Cayenne DME P242100 – Fuel Tank Isolation Valve for Tank Ventilation System - Stuck Open

Vehicles Affected

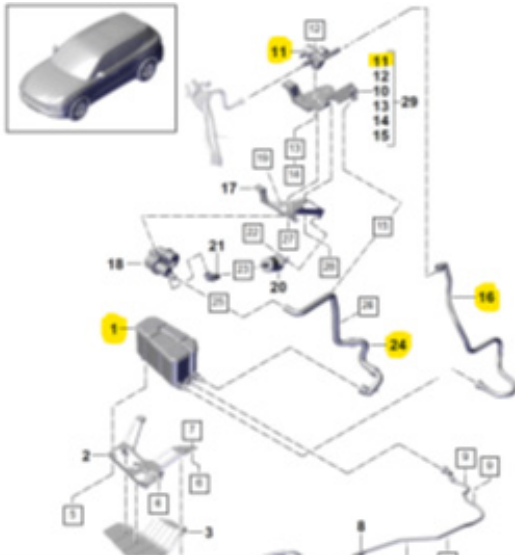
Carbon deposits from the carbon canister may impair the sealing function of the sealing membrane in the tank ventilation system.

Please replace these four components shown in yellow below:

1)	PAB 201 801 C	Evaporative Emission Canister
11)	PAB 201 549 B	Pressure Regulator
16)	PAB 201 183	Breather Line
24)	PAB 201 999	Vent Hose
